# PTS Consistency Effort

## **Problem Statement:**

# Consistency Effort Data Sheet

Oconee Case 109 (black) -vs- Oconee Case 112 (red) -vs- Oconee Case 113 (green)

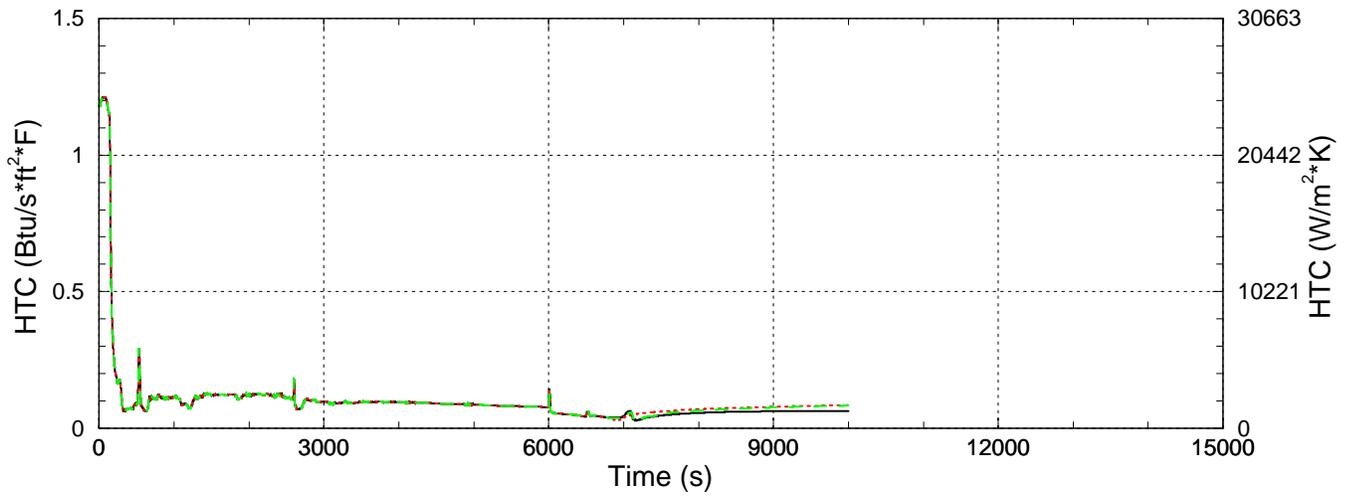
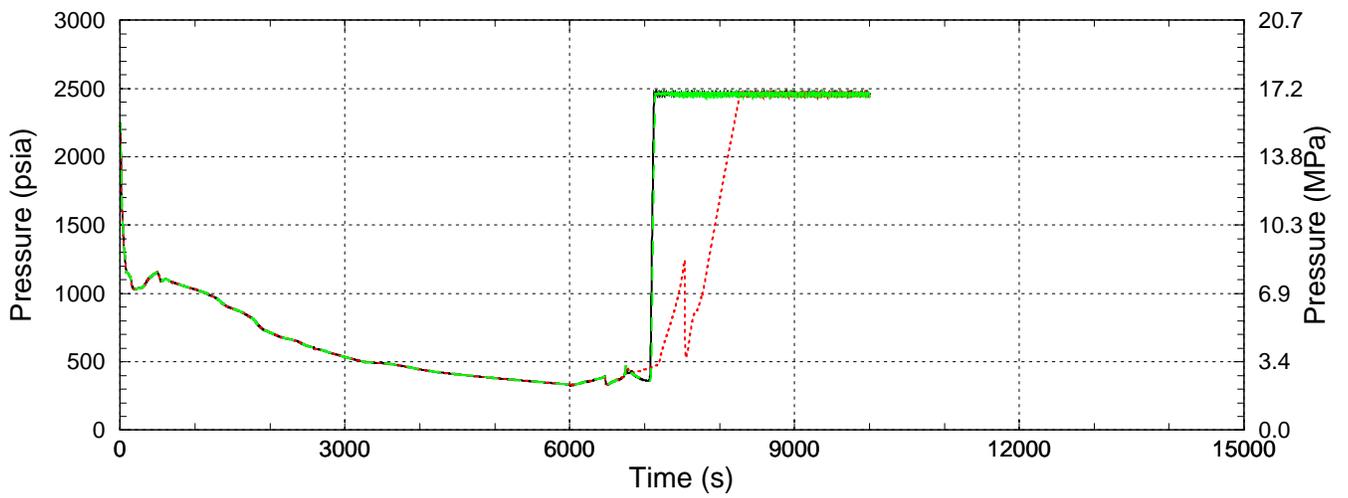
Pressure and Temperature will decrease. When HPI is throttled, pressure should be controlled and temperature will increase faster.

The HPI throttling did not control RCS pressure. Heat output of the core was high and re-pressurized the RCS.

Oconee Case 149 (black) –vs– Oconee Case 114 (red) –vs– Oconee Case 115 (green)

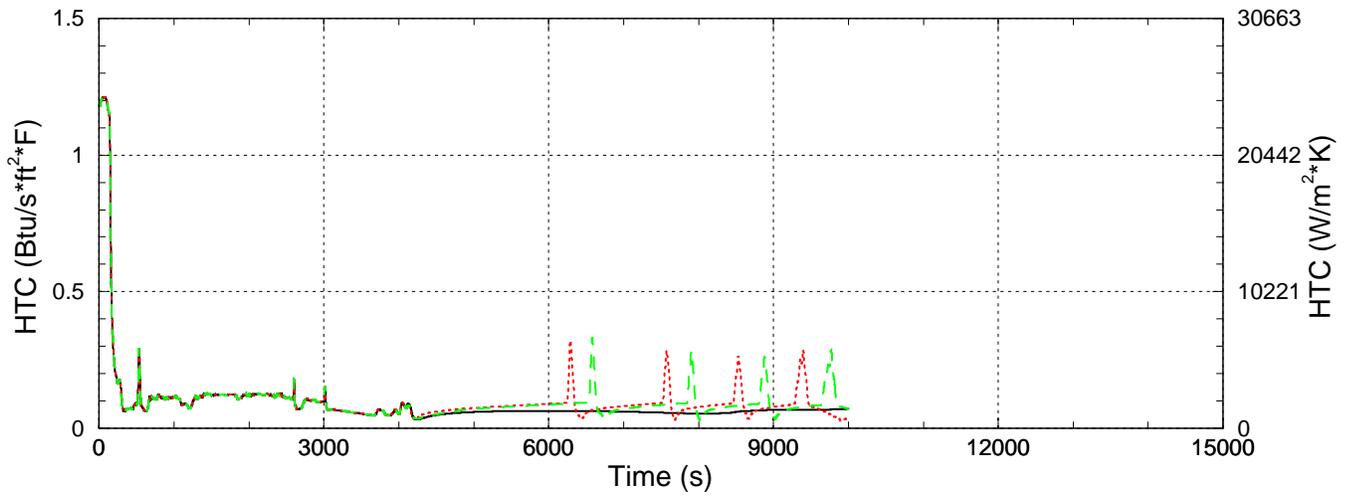
Pressure & Temperature will decrease. HPI throttling should control press. After throttling HPI, temperature should increase due to the reduced flow into the core.

Heat output of the core in the HFP case causes the RCS pressure to increase even through HPI throttling. The temperature & pressure spikes between 6000s and 10000s are attempts of the RCS to start natural circulation. When natural circulation initiates, the pressure and temperature decrease until conditions are not optimal.

Beaver Valley Case 071 (black) –vs– Oconee Case 165 (red) –vs– Palisades Case 065 (green)

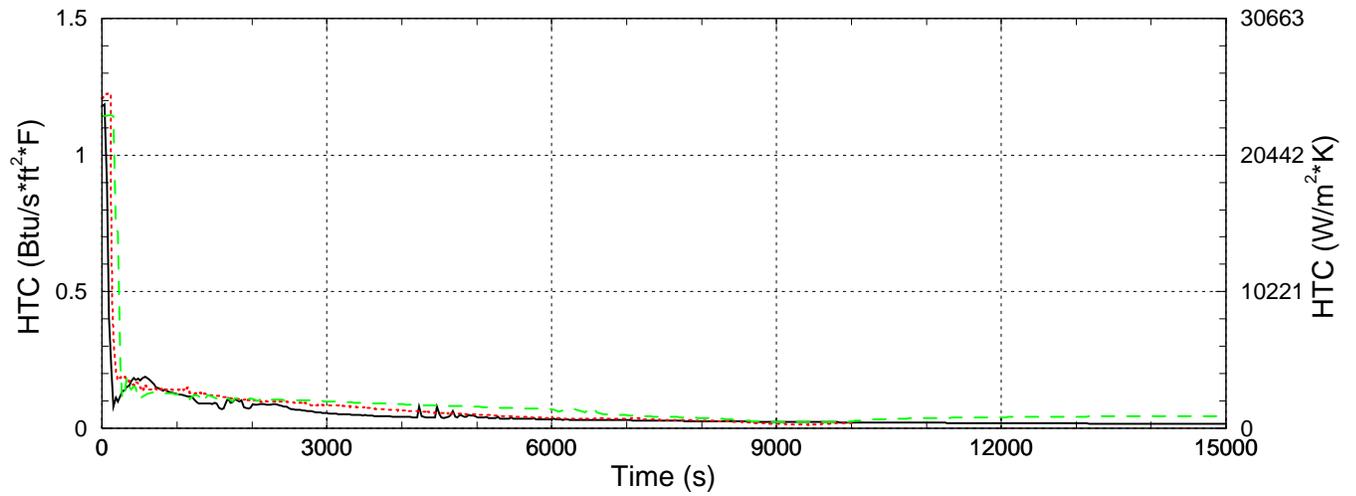
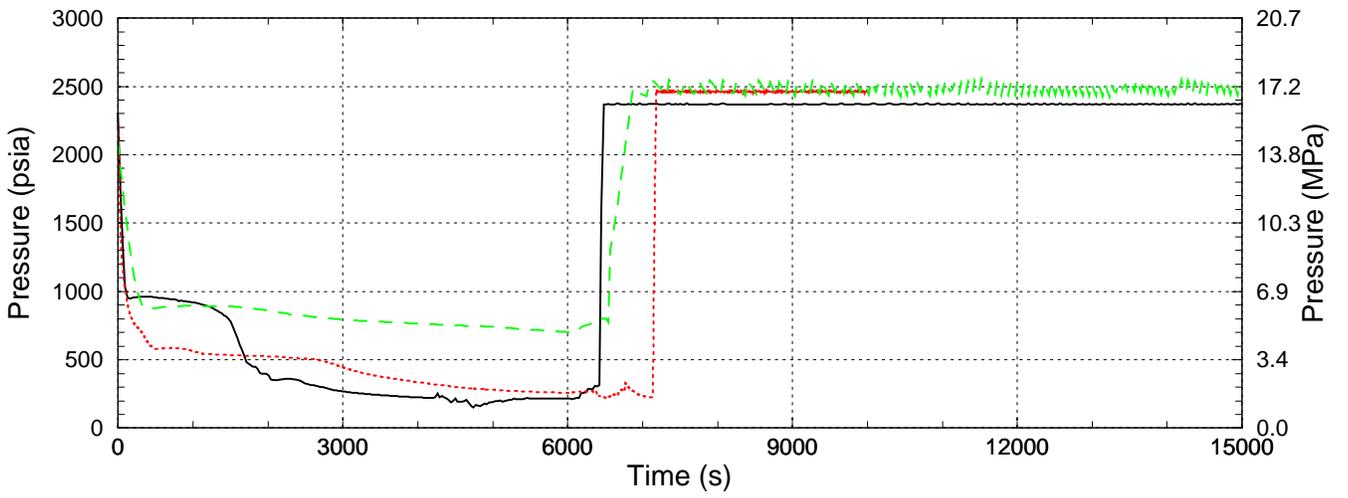
Pressure & Temperature will decrease. The decrease will be based on the SRV size. The larger valves will cool down and lose pressure faster.

Palisades has small SRV's and the HPI system is not high head pumps therefore flow to the RCS is less and temperature will not decrease as much. These low head pumps also effect how fast the RCS refills after valve re-closure.

Beaver Valley Case 098 (black) -vs- Oconee Case 112 (red)

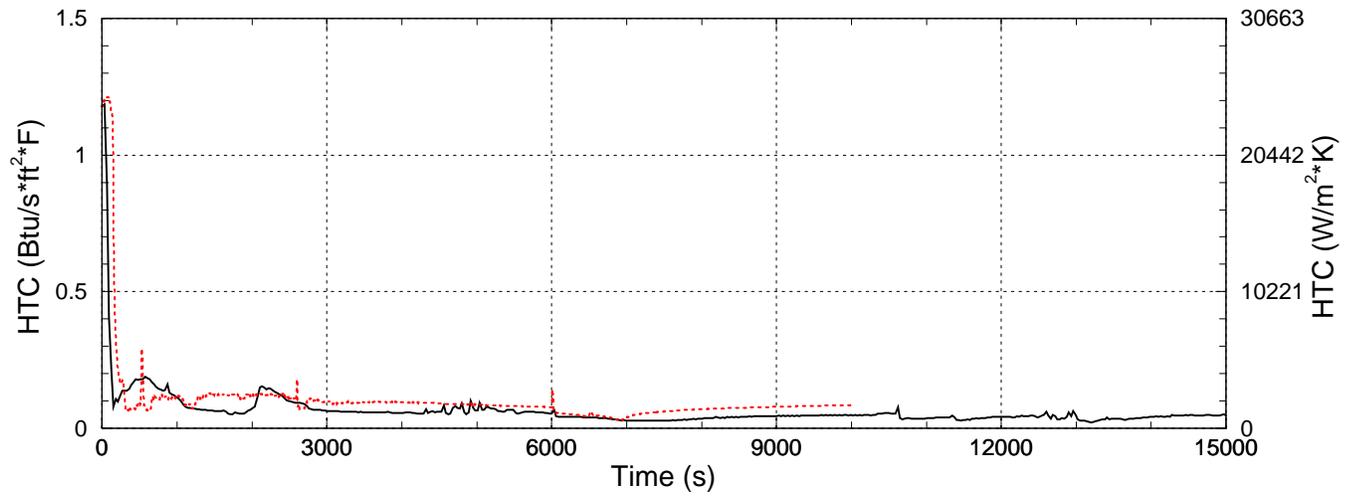
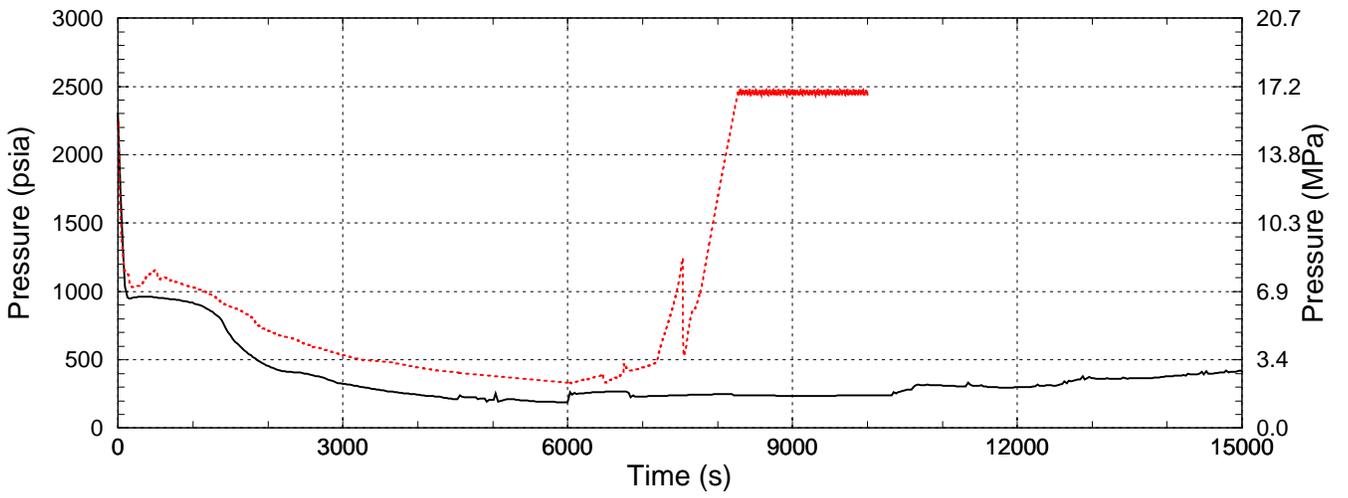
Pressure& Temperature curves should track well.

Temperature charger for BV at 1000s is due to HPI throttling subsequent decrease is due to SIT injection/LPI.  
Pressure& Temperature for the HFP case is higher due to the heat load of the RCS.

Beaver Valley Case 100 (black) -vs- Oconee Case 122 (red)

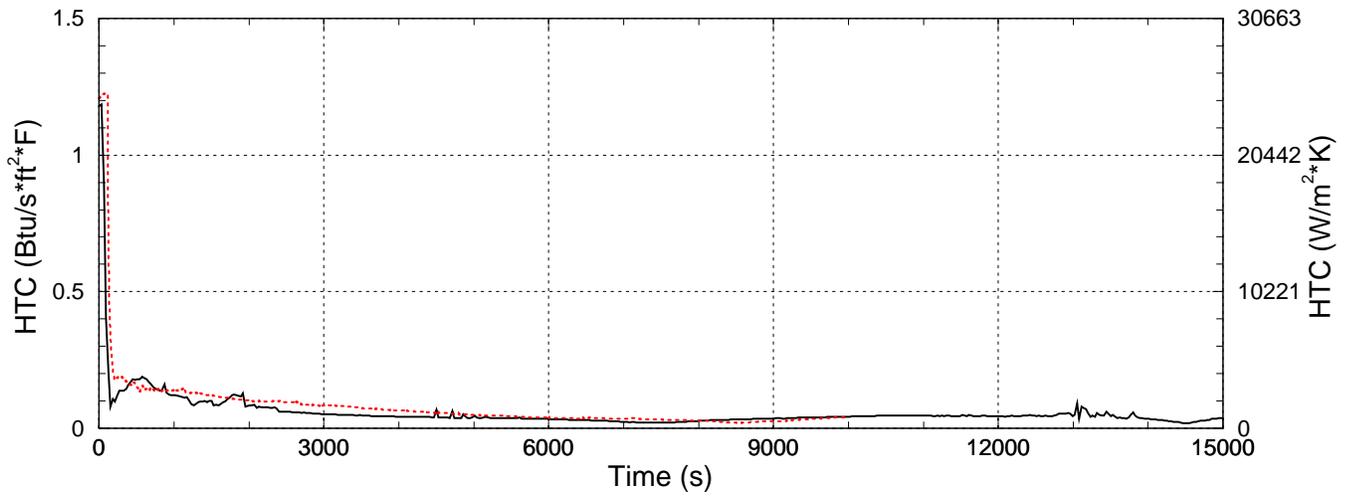
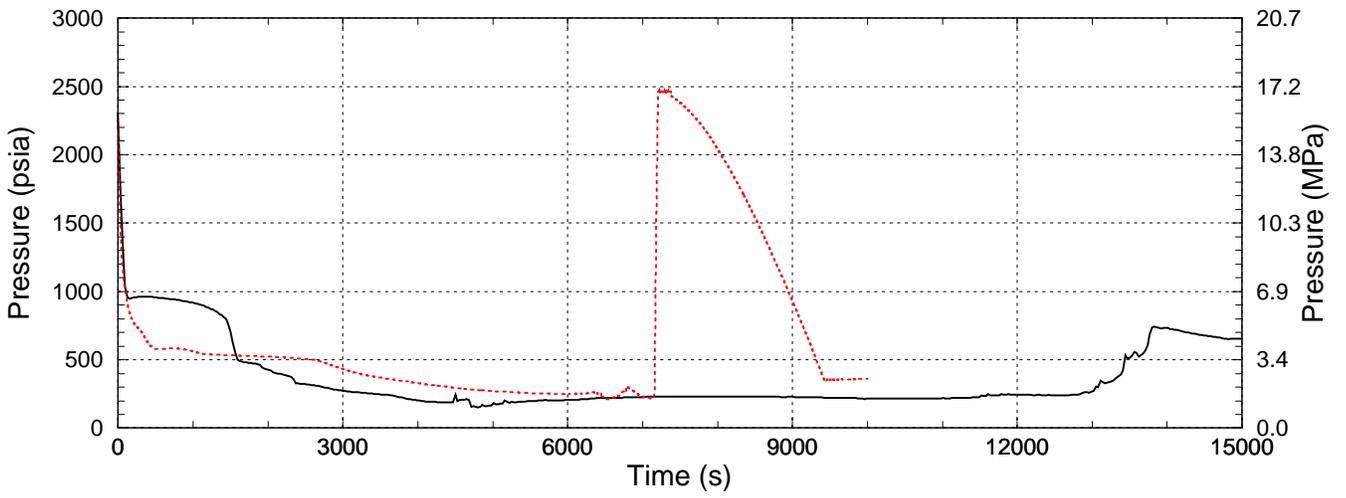
Pressure & Temperature curves should track well with the HFP case slightly higher.

Pressure peak at 7000s is due to HPI injection throttled too late to compensation for the heat load in the RCS, due to the HFP case.
